DATE: November 10, 2016

TO: PLANNING COMMISSION

RE: Modification to Approved Small Lot Vesting Tentative Subdivision Map 06-05
(Montecito Place)
Located South of Nord Highway and West of Esplande; APNs 006-690-011, -012

MONTECITO SUBDIVISION INVESTING TENTATIVE SUBDIVISION MAP (S 06-05)

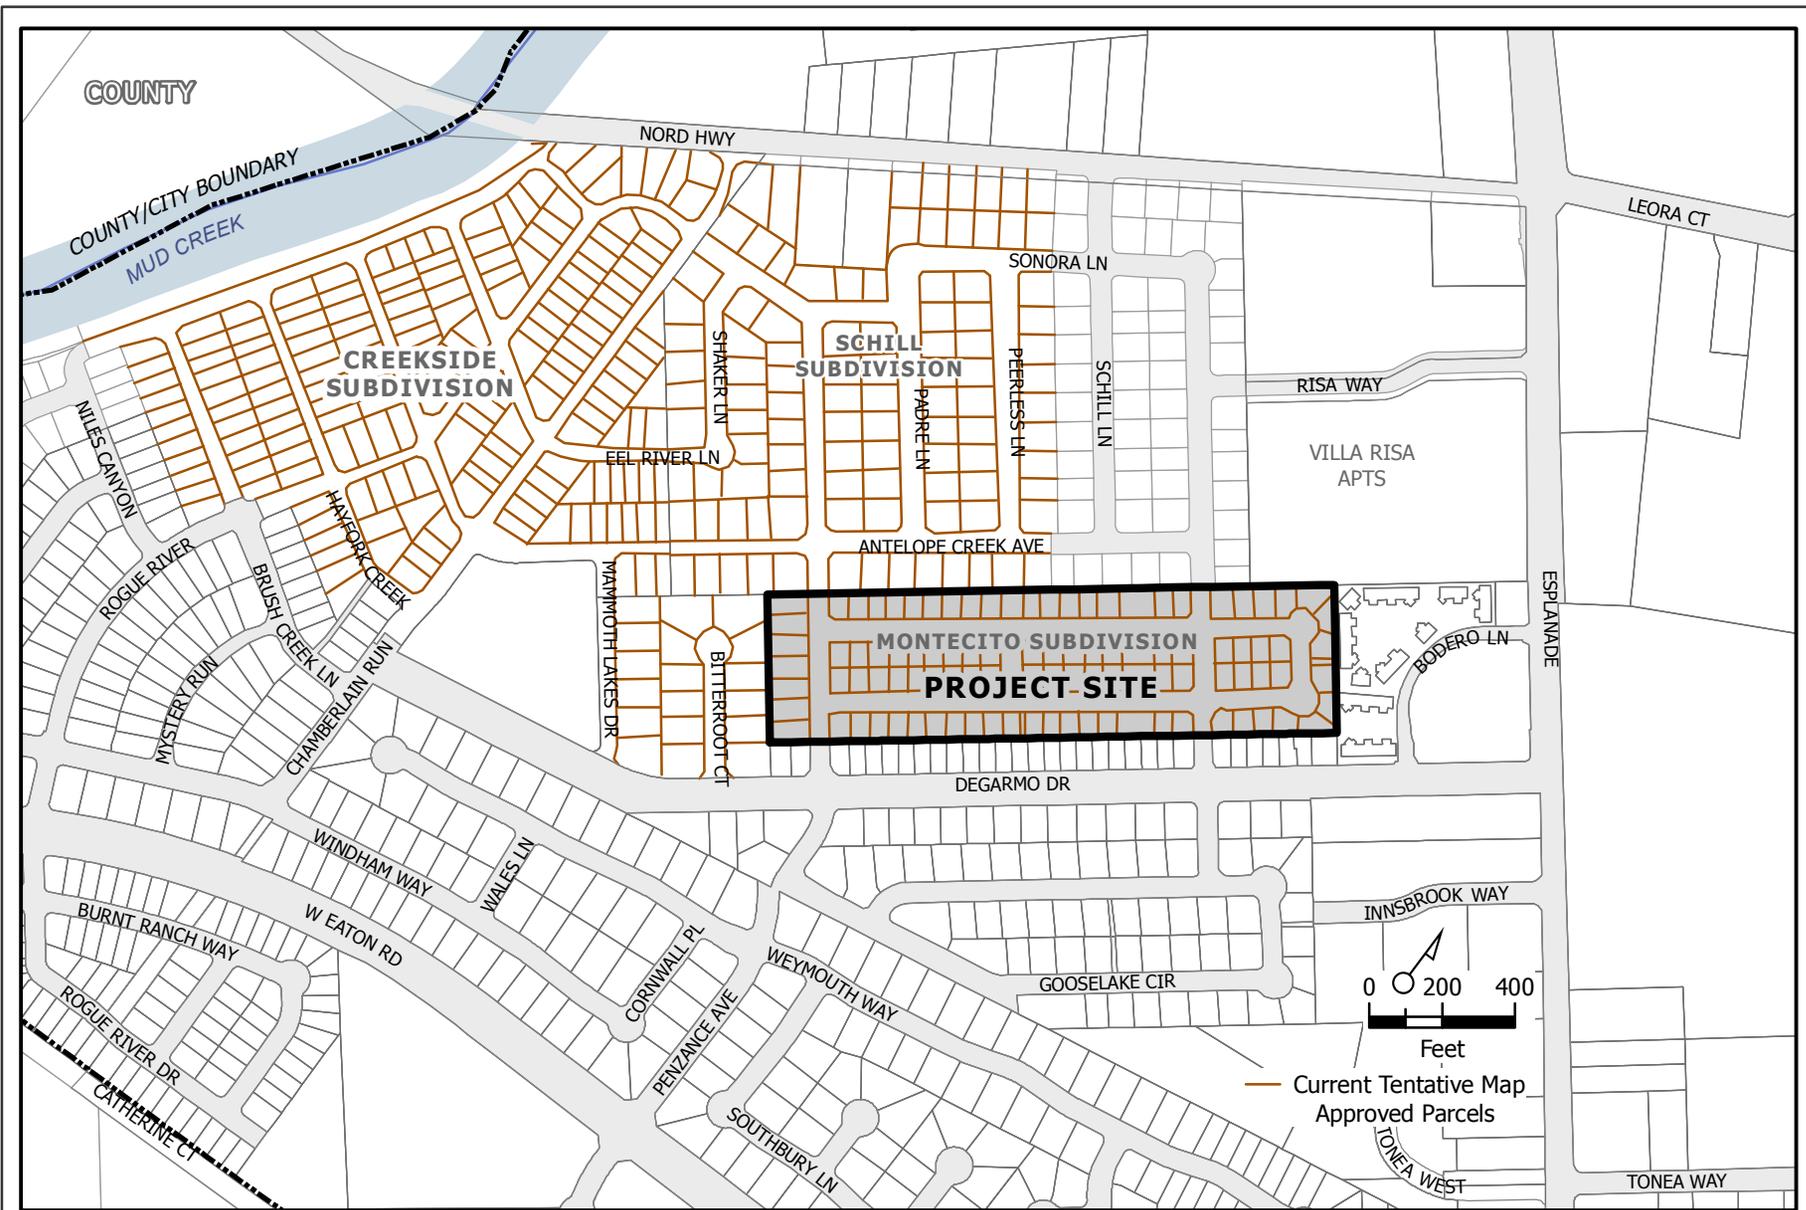
The applicant proposes to modify approved Small Lot Vesting Tentative Subdivision Map S 06-05. The proposal would eliminate a 12 foot wide bicycle/pedestrian path from between lots 93 and 94 and a nine (9) foot wide bicycle/pedestrian path from between lots 33 and 78 of the approved vesting tentative map. No significant concerns have been identified.

The proposed modification would include the elimination of a 12 foot wide bike path between lots 93 and 94 that would connect Street D (Antelope Creek) of the approved Schill subdivision

(S 06-02) with Bentwater Loop to the south after passing between lots 93 and 94 of the approved Montecito Place subdivision (S 06-05). The proposed modification also includes a request to remove a nine (9) foot bicycle/pedestrian path from between lots 33 and 78 that would connect Bentwater Loop with an adjacent multi-family residential project to the northeast (see **Attachment C**). Prior to the current approved street layout for the subdivision, the Northwest Chico Specific Plan included development of the site as incorporating multiple cul-de-sacs in the planned circulation network (see **Attachment D**). The incorporation of the cul-de-sacs in the circulation network would have resulted in the need for increased bicycle and pedestrian paths to allow the Specific Plan to conform to the General Plan Goals for Circulation (CIRC-1.2, CIRC-2.1, CIRC-3, and CIRC-4) and Community Design (CD-2.1, CD-3.2). A redesign of the approved subdivision eliminated cul-de-sacs from the street network and therefore increased pedestrian and bicycle connectivity throughout the project site. The redesigned street layout allows the proposed project area to be consistent with the goals of the Northwest Chico Specific Plan to develop and multi-modal circulation pattern that facilitates connectivity from residential neighborhoods to both the Esplanade and the area's open space amenities as well as previously listed General Plan goals for Circulation and Community Design.

7. The final map shall illustrate bulbed intersections as set forth in the NWCSP.
8. ~~The final map shall illustrate the Class I pedestrian/bicycle path between Lots 78 and 33 being a minimum of 12 feet wide.~~

19. ~~The final map shall illustrate a 12-foot wide Class I pedestrian/bicycle path between Lots 93 and 94 and aligning with the pedestrian/bicycle path of the Schill Subdivision adjacent to the north and generally aligning on the south with Street 'B' of the Montecito Place tentative subdivision map.~~

Planning staff recommends adoption of Resolution No. 16-21 (**Attachment A**), approving modification to approved small lot vesting tentative subdivision map S 06-05, subject to the attached conditions.

FIGURE 5-15

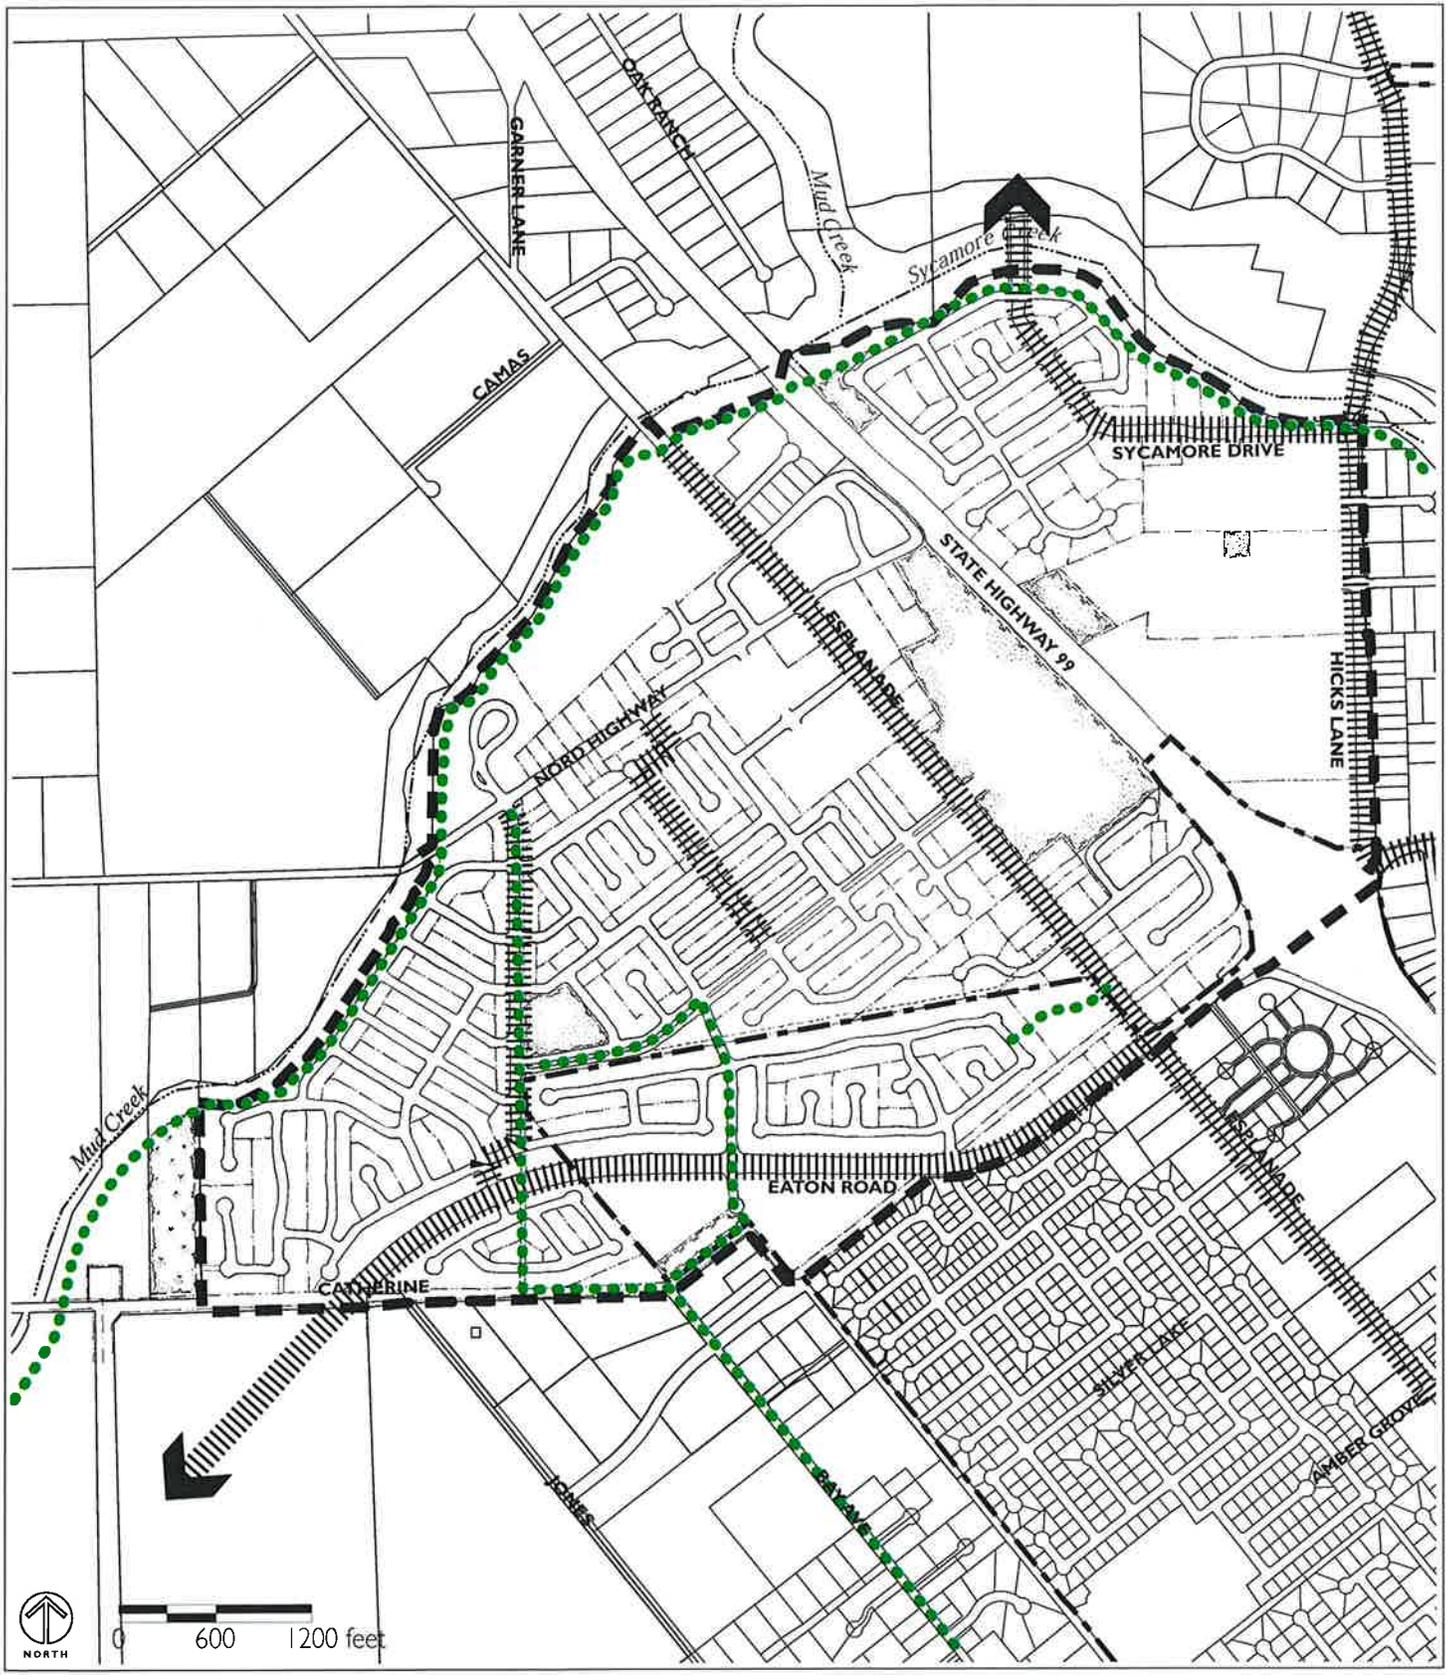
The Planning Commission's decision to modify the conditions of approval creating this path is without merit. When the Northwest Chico Specific Plan (NWCSP) was being considered it depicted Schill subdivision with multiple cul-de-sacs(Fig. 5-15). Concurrent with the adoption of the NWCSP and proposed Schill subdivision, modifications to the street layout replaced the cul-de-sacs with through roads. This results in a greater connectivity for both vehicle and pedestrian traffic. Furthermore, these short inter-connected bike paths adjacent to homes have proven to be both a maintenance problem and public safety issue.
